**Voluntary Emissions Recall Campaign 10E-A02: N54 Inspection and Replacement of Injectors**

E60, E61, E71, E82, E88, E90, E92, and E93 with the N54 engine produced from 04/02/2007 through 10/31/2008

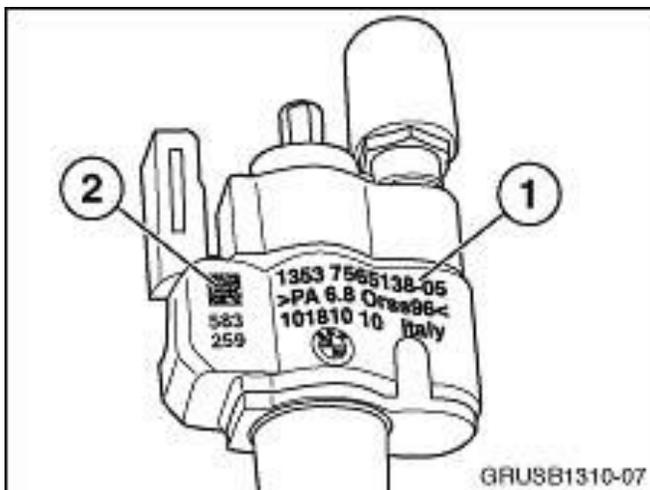
Check the injectors' production date/serial numbers (using the DMC scanner) and replace if required.

1. Remove the engine's acoustic cover following REP11 00 "Remove and refit/replace ignition-coil cover (N54/N54T)".
2. Check each injector's part number and index number (indicated as # 1), which are located on the injectors' plastic housing facing the ignition coil.
3. **IMPORTANT:**

Injectors with P/N **13 53 7 585 261 04-08** index are not affected by this Service Action and should not be replaced.

Injectors with PN/index **13 53 7 537 317-xx** or **13 53 7 565 138-01** up to **7 565 138-07** must be carefully removed in a sequential order (following REP13 53 310) and marked with the cylinder number.

For the injectors already removed, scan the rectangular bar code located in the upper left part of the plastic housing, next to the injectors' part number (indicated as # 2 in the illustration). The 34 or 36-digit line should appear in the corresponding cylinder's line.

9. After all 6 cylinders' fields are filled out, continue with **Check** selected from the bottom menu bar.
10. Defective or "unreadable" injectors are going to be marked "**Replace**" (red field). Use P/N **13 53 7 585 261** for the replacement.

Injectors identified as "**OK**" (green field) should NOT be replaced, but they should be reinstalled into corresponding cylinders after replacement of the PTFE Sealing ring (P/N 13 53 7 584 315) and decoupling element (P/N13 53 7 564 751), following REP 13 53 310.
